NEWTON STEWART FLOOD PROTECTION SCHEME

VM DOCUMENT

25 AUGUST 2017

Change list

Figure 2-3 - Upstream Storage at Frankie Hill

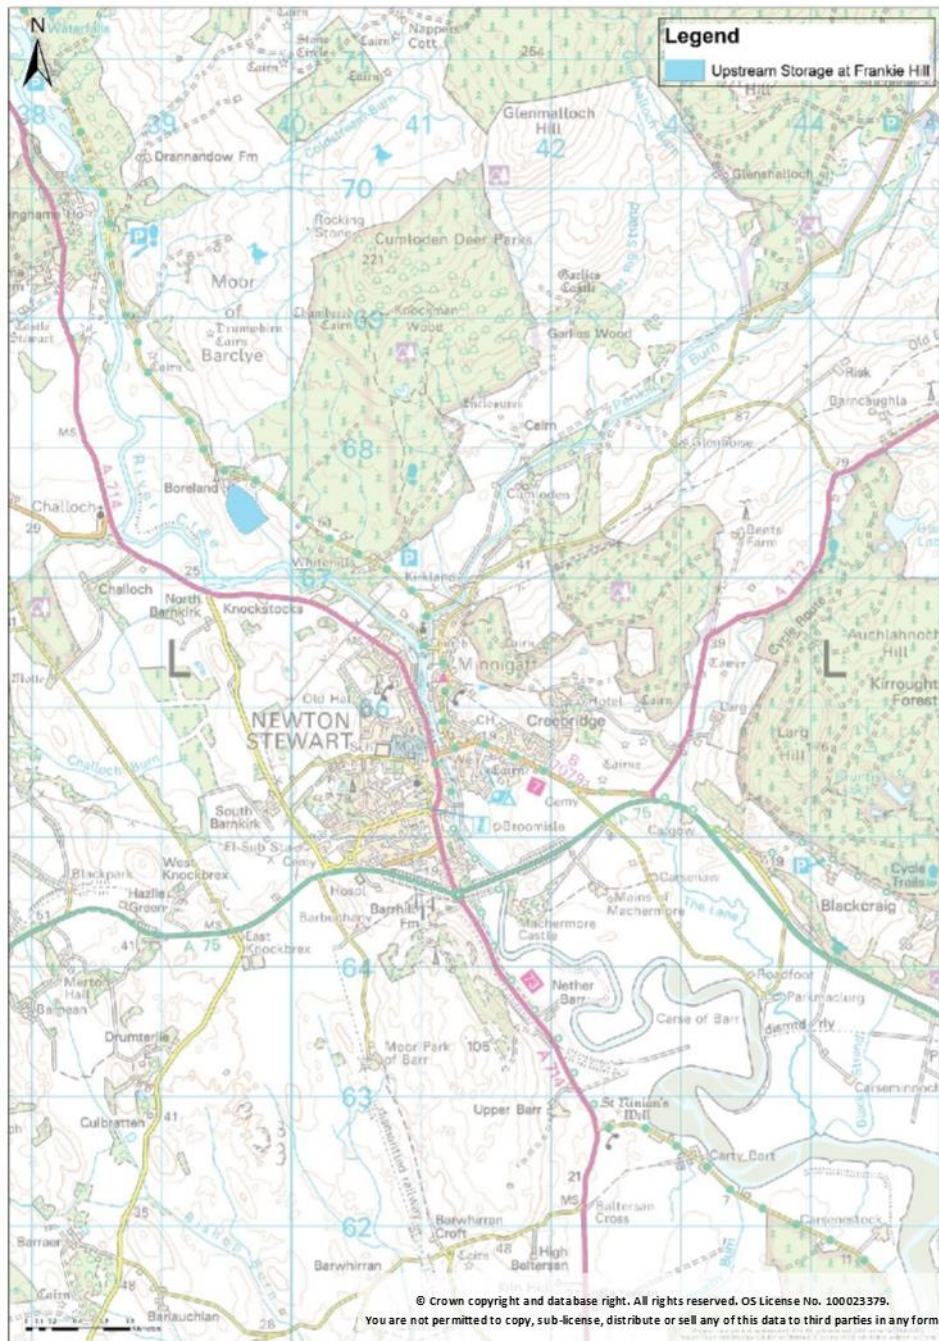
Kaya Consulting noted that from their previous modelling expertise of the local area, it was felt that this would only reduce flows within the town by around 10 m³/s – which is a very small reduction and far from the required standard of protection.

Further discussion at the VM1 meeting clarified this option as being split across two tributaries; which meant that the cost would be greater due to the need to construct two impoundments. A consensus was reached that option 2 would be a preferred off-line storage area in comparison to option 3.

Option to be removed, and should not proceed to the short-list. The primary reason for this was that the storage volume was low and would likely have minimal or no effect on flood risk within the town.

Figure 2-4 - Possible Locations for Obstructions on the River Cree

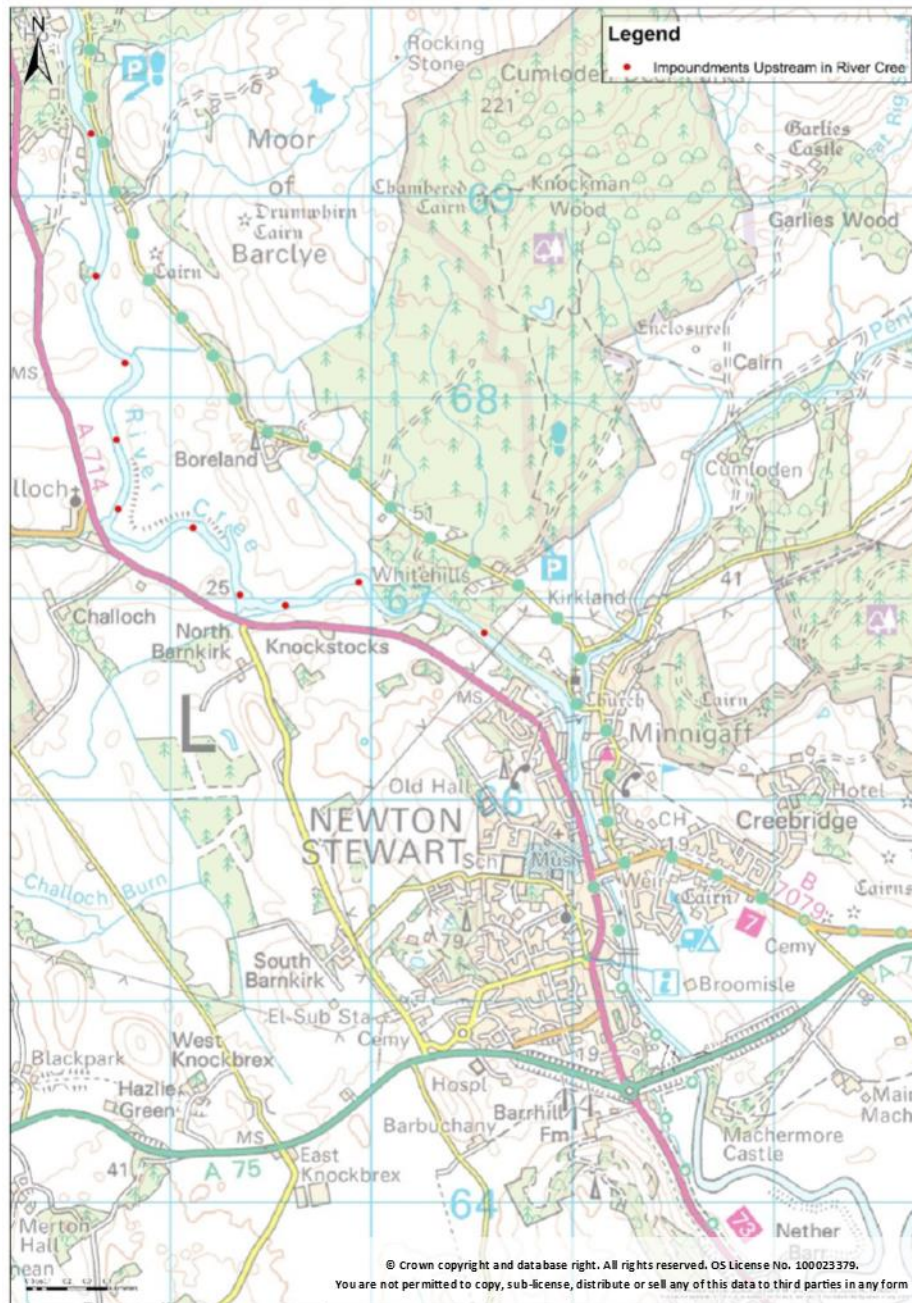
Kaya Consulting was asked to model this option ahead of the VM1 meeting and came with the conclusion that it would likely only reduce flood water levels at the 1:200 year return period by around 5-10%.

Galloway Fisheries have stated that they would consider this option to have issues for them due to the potential for erosion and impediment to fish passage. This option could potentially be a big concern for fisheries. SEPA echoed the concerns of Galloway Fisheries.

This option is to be taken forward to the short-list for additional investigation. Additional hydraulic modelling at lower return periods (1:200 year already modelled) is to be conducted to consider the effect of this option on less extreme events.

Figure 2-5 - Possible Locations for Obstructions on the Penkiln Burn

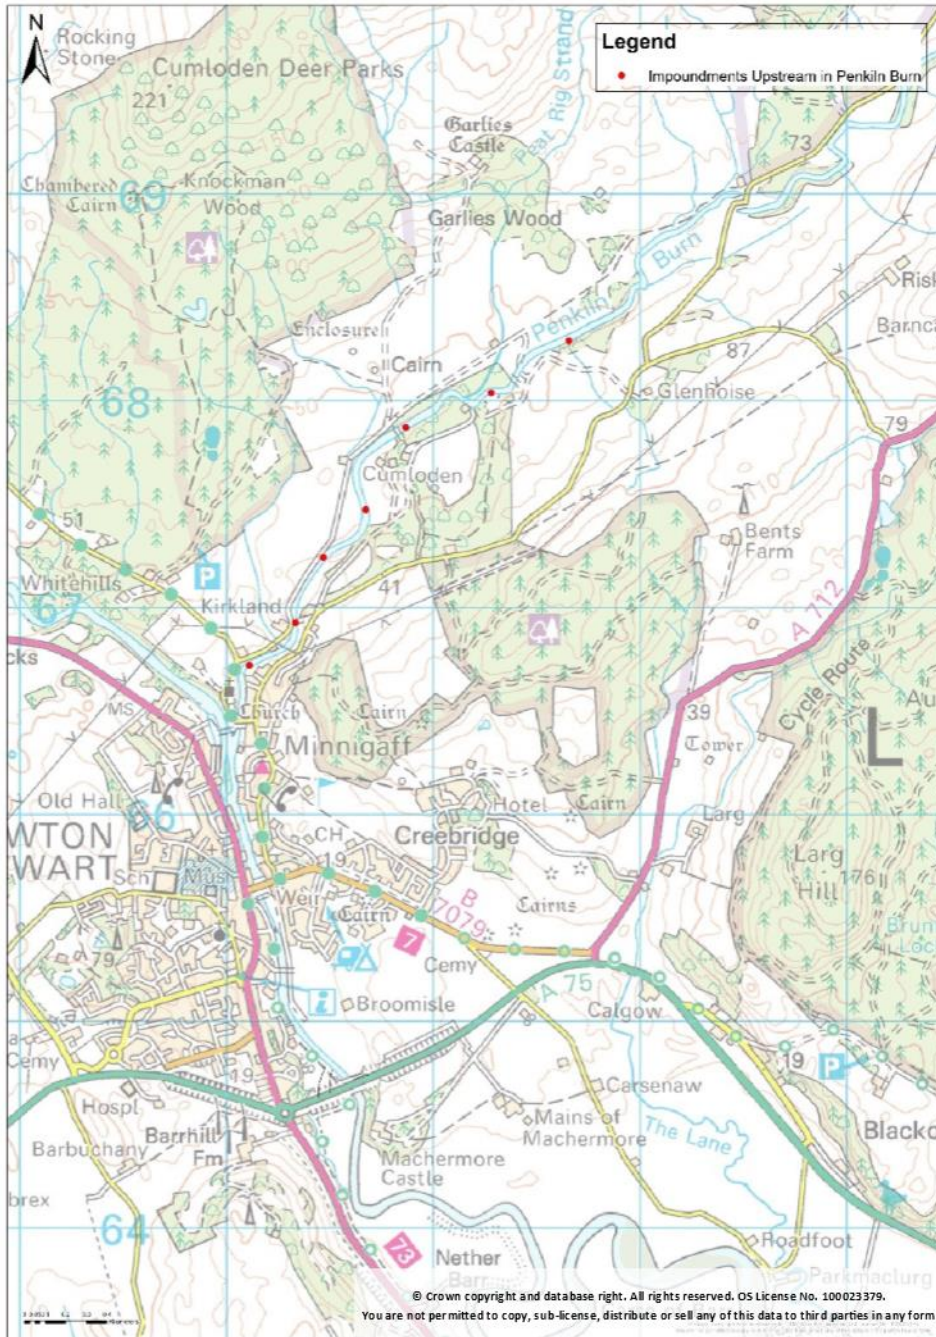
The consensus reached at the VM1 meeting is that this option would likely have minimal impact due to the relatively small proportion (approx. 15%) of flows towards the town originating in the Penkiln Burn.

Option to be removed, it should not proceed to the short-list. The reason for this is the low proportion of flows entering the town from the Penkiln Burn (approximately 15% of total flows) meaning that interventions here are likely to have minimal or no impact on flood risk.

Figure 2-6 - Potential Area of River for Direct Defences

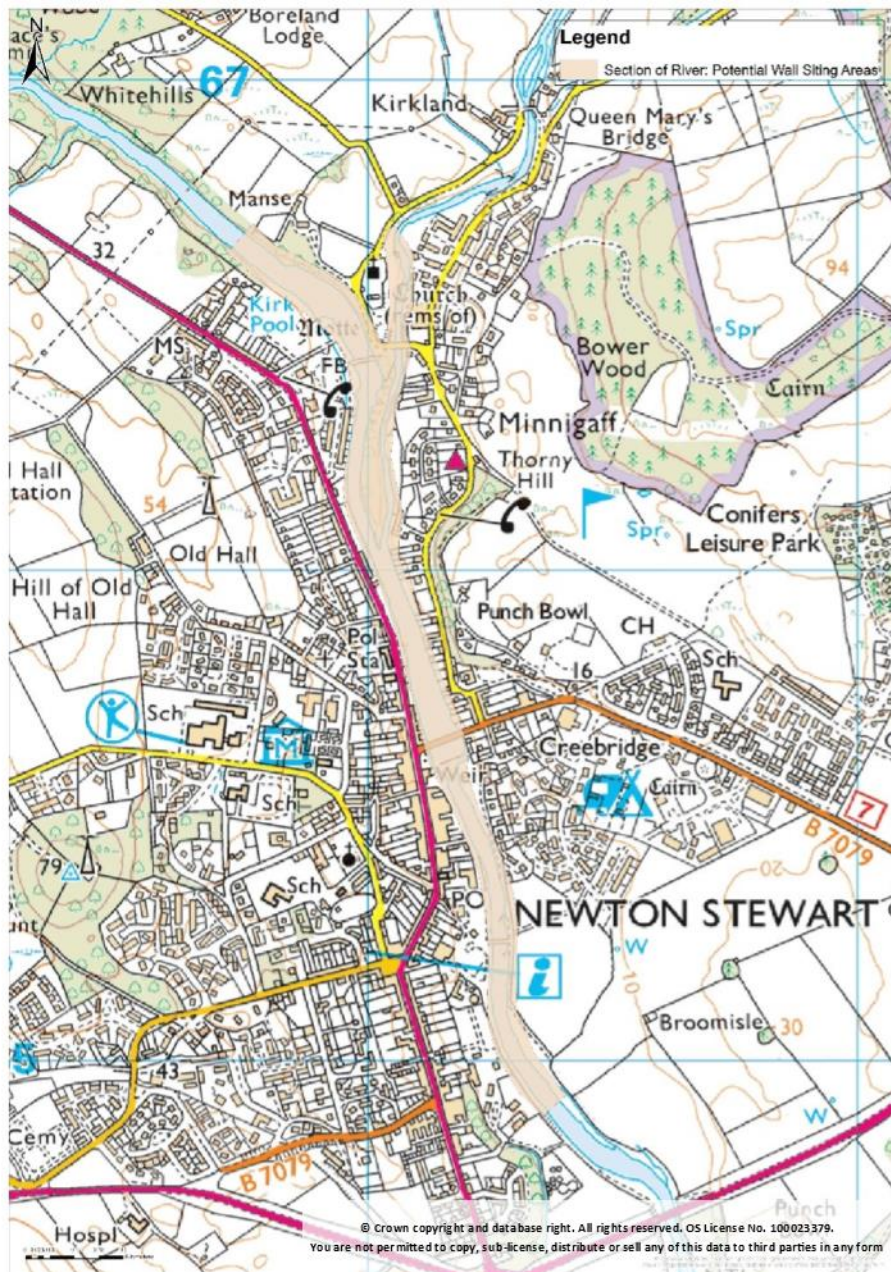
CVCC noted in a letter to DGC ahead of the VM1 meeting that this option was a high preference, with the reason being the importance of protecting the commercial heart of the town. There was consensus among stakeholders at the VM1 meeting that there was an inevitability that some form of direct defences would be required.

This option is to be taken forward to the short-list for additional investigation. It was considered that this option will be required in some way, even in combination with other options.

Figure 2-7 - A75 Bridge Location

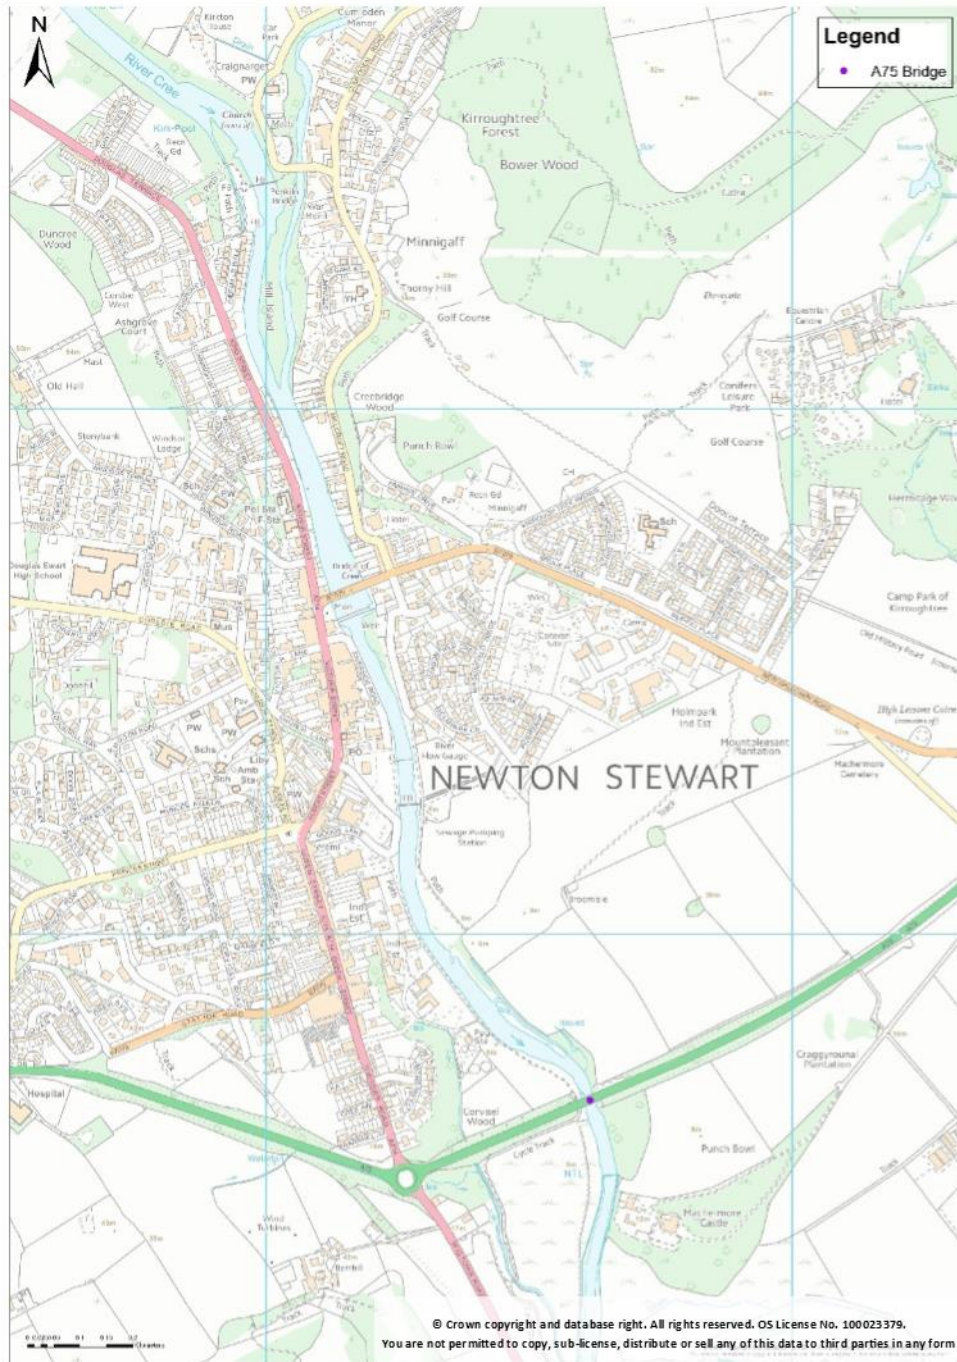
CVCC noted in a letter to DGC ahead of the VM1 meeting that either this option or option 9 should be taken into consideration as they feel the embankment effectively dams the natural floodplain.

Galloway Fisheries noted that this is a spawning location, and downstream of the A75 crossing is a SSSI. As such any modifications here should carefully take these facts into account.

Further discussion noted that while the option would remove a social amenity (path/cyclepath), the scheme design would likely be in a position to replace this amenity in a similar location so that there was no overall loss.

Kaya Consulting previously carried out some modelling in the area which indicated benefits were localised and consequently not effective at reducing flood risk in the urban areas upstream, although it was agreed that further work could be completed to provide a more detailed insight to the potential impacts.

This option is to be taken forward to the short-list for additional investigation. Further hydraulic modelling once additional survey information has been gathered to refine the assessment of this option is needed to fully understand the potential here.

Figure 2-8 - A75 Embankment Location

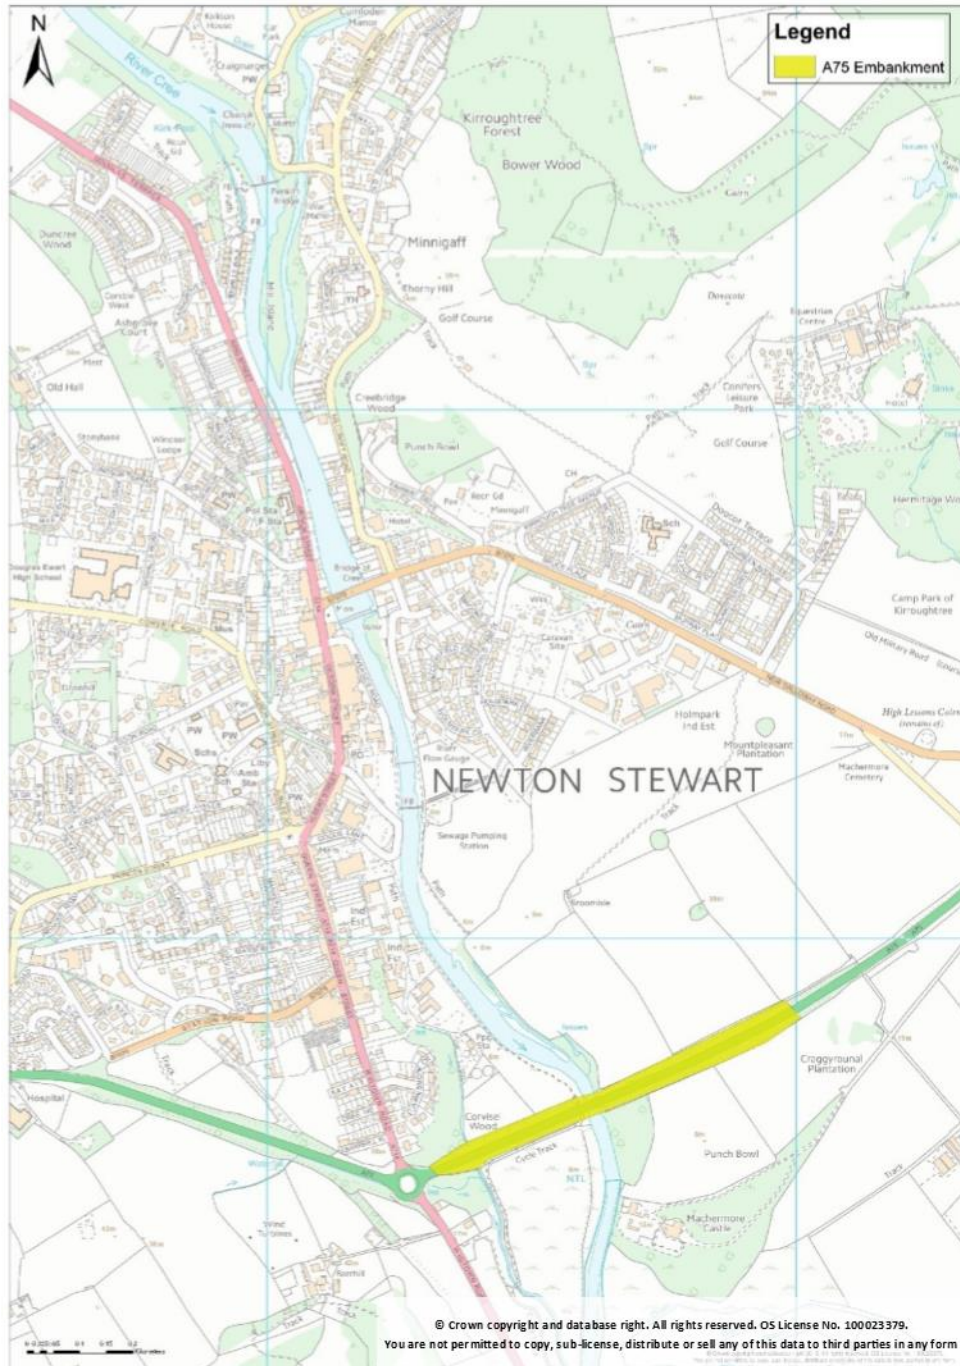
Kaya Consulting carried out some modelling work on this idea, which was found not to have a significant impact on flood levels further upstream at the town. Locally, this lowers levels up to 1m – but this reduction effect decreases quickly moving upstream.

Antony Berretti (Community Council) noted that there were effects seen downstream of the bridge since the construction of the A75. This has been in the form of an altered sediment erosion/deposition regime.

Option to be and removed, and should not proceed to the short-list.. This was due to the high complexity and likely high cost of completely removing and replacing the embankment – and also the associated disruption to the town implementation of the option would likely cause.

Figure 2-9 - Flood Relief Culverts Beneath A75

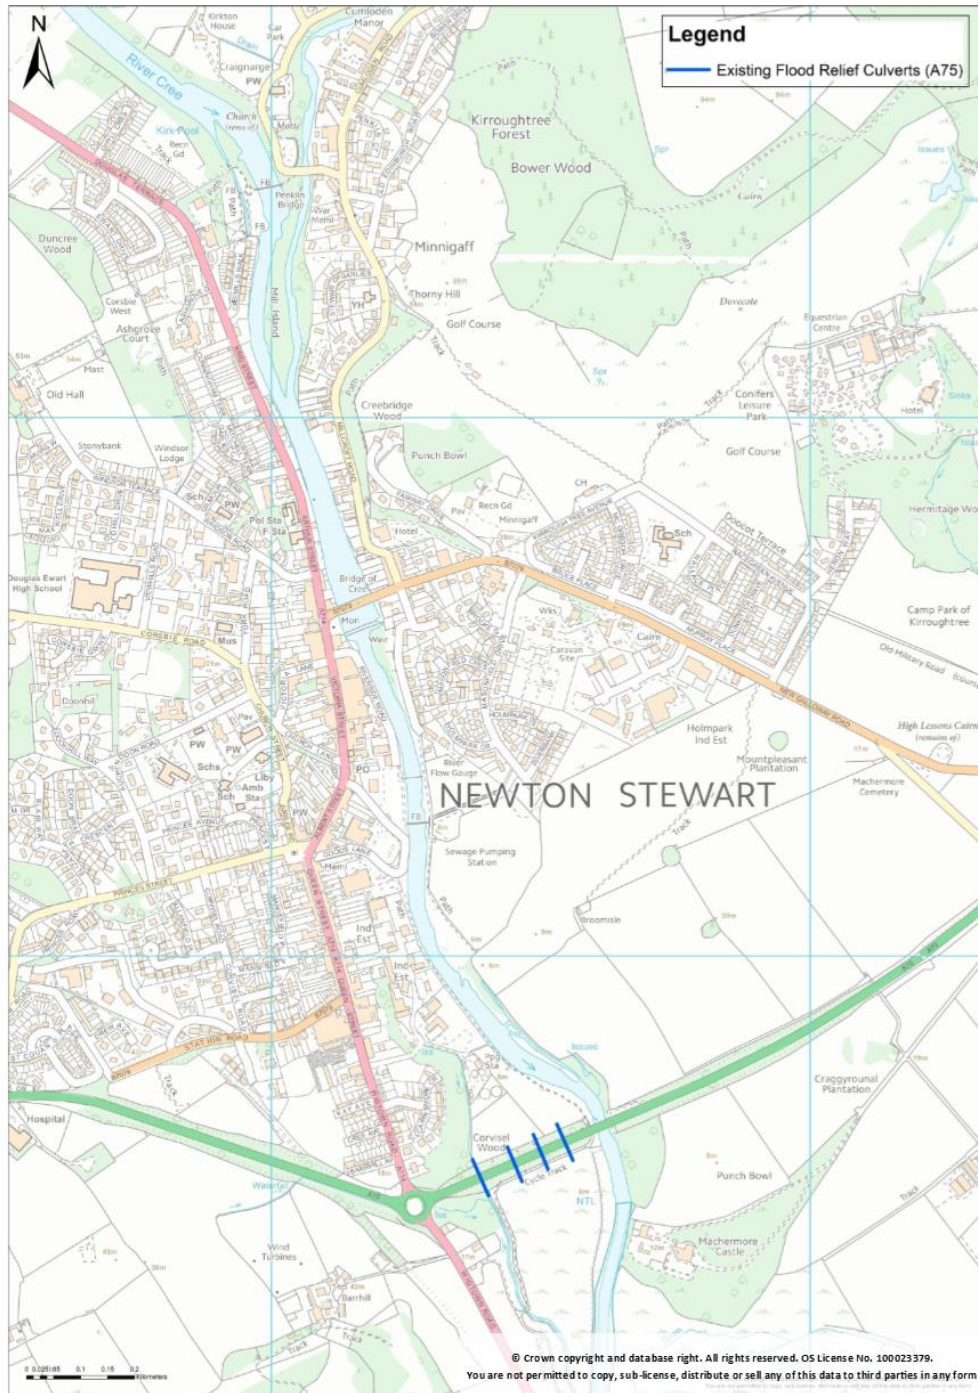
CVCC noted in a letter to DGC ahead of the VM1 meeting that either this option or option 7 should be taken into consideration as they feel the embankment effectively dams the natural floodplain.

Discussion at the VM1 meeting suggested that the current flood relief culvert system was not working well. It was considered that upgrading them, and finding improved flow paths was likely a useful low cost solution; although could not be considered alone.

This option is to be taken forward to the short-list for additional investigation. It was felt that this would at least contribute to lowering water levels at the town if implemented well. Further hydraulic modelling of this option is to be carried out following receipt of additional survey data to investigate its potential.
